**ENGINE SYSTEMS, INC.**

**10CFR21 REPORTING OF DEFECTS  
AND NON-COMPLIANCE**

**COMPONENT:** Excitation Transformers for Vickers Voltage Regulator System

**SYSTEM:** Emergency Diesel Generator – Voltage Regulator System

Figure 2: EPT Outline Drawing

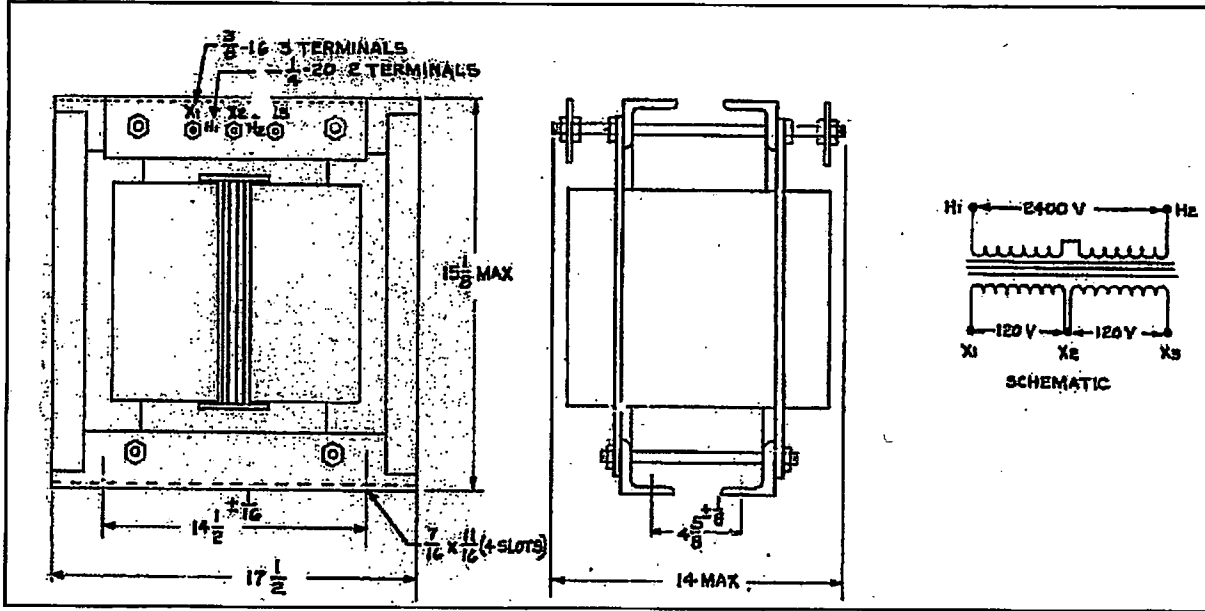
Three single-phase EPTs are wye connected on the primary and delta connected on the secondary. Per the system design, EPT primary H1 should have the same polarity of EPT secondary X1. Contrary to this requirement, EPT primary H1 has the same polarity as secondary X3.

*Return to ESI for rework to have EPT primary terminal markings (H1 & H2) re-labeled.*

Figure 3: PCT Outline Drawing

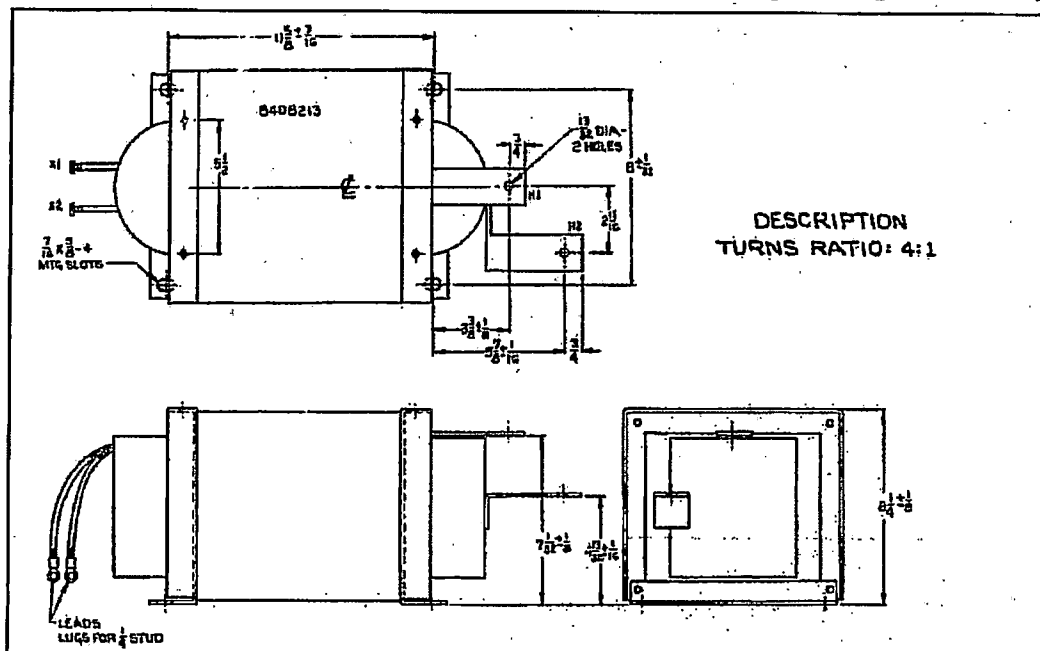
Three single-phase PCTs provide a secondary voltage proportional to the primary current. The PCT, in conjunction with the EPT, provide the power to support generator field excitation. Certain characteristics of the PCT secondary voltage are determined by the magnitude of an air gap in the core construction. It has been determined the PCT supplied by ESI has a gap of 0.030" whereas the original design PCT has a gap of 0.080".

*Return to ESI for rework. The PCT requires additional insulating material to increase the core gap.*

Figure 4: Reactor Outline Drawing

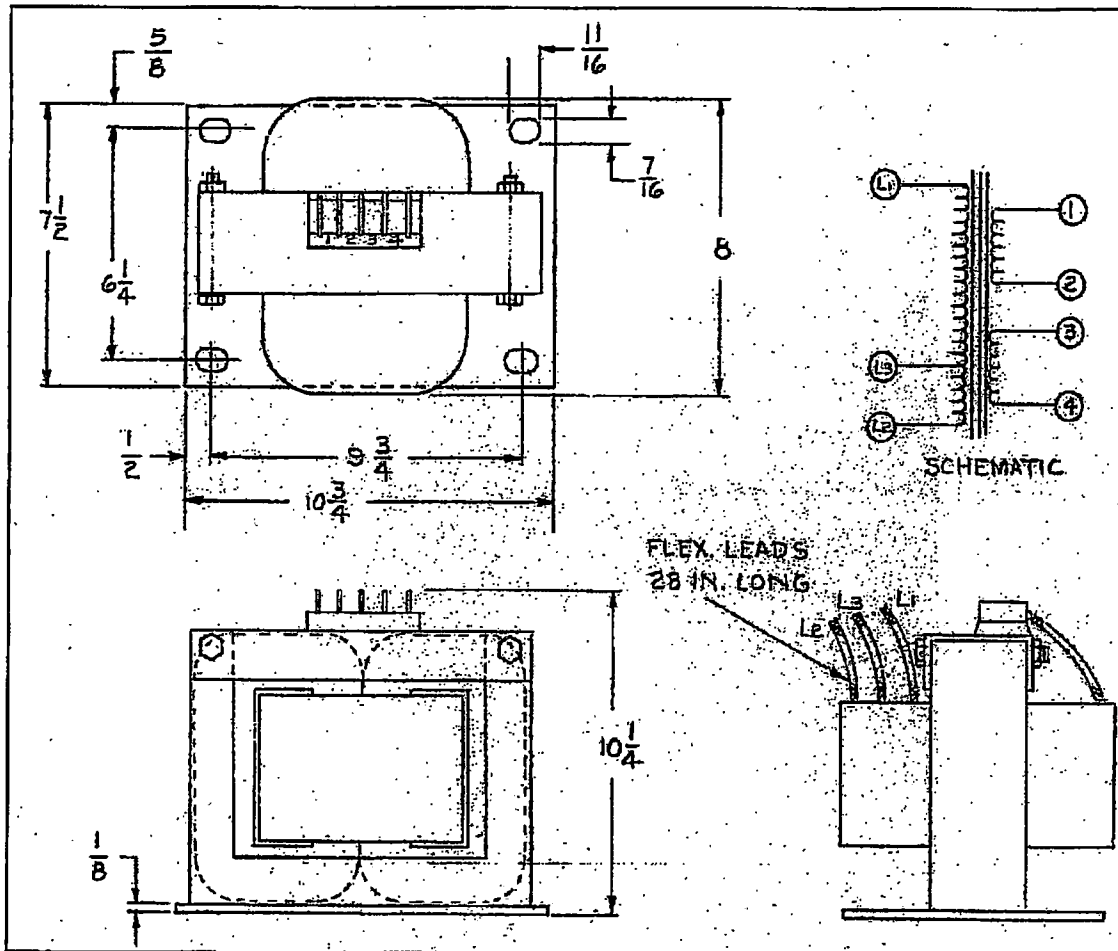
In conjunction with a rectifier diode, the saturable reactor acts as a magnetic amplifier. Six of these magnetic amplifier assemblies are used in the rectifier bridge of the voltage regulator system. The reactor receives a bias and control current from the voltage regulator which varies the level of saturation in the reactor core. As the level of saturation changes, the reactor impedance varies which increases or decreases generator field voltage. It has been determined the saturable reactor supplied by ESI has coil winding and core winding differences from the originally supplied reactor that may cause subtle, but undesired performance differences.

*Return to ESI for replacement.*
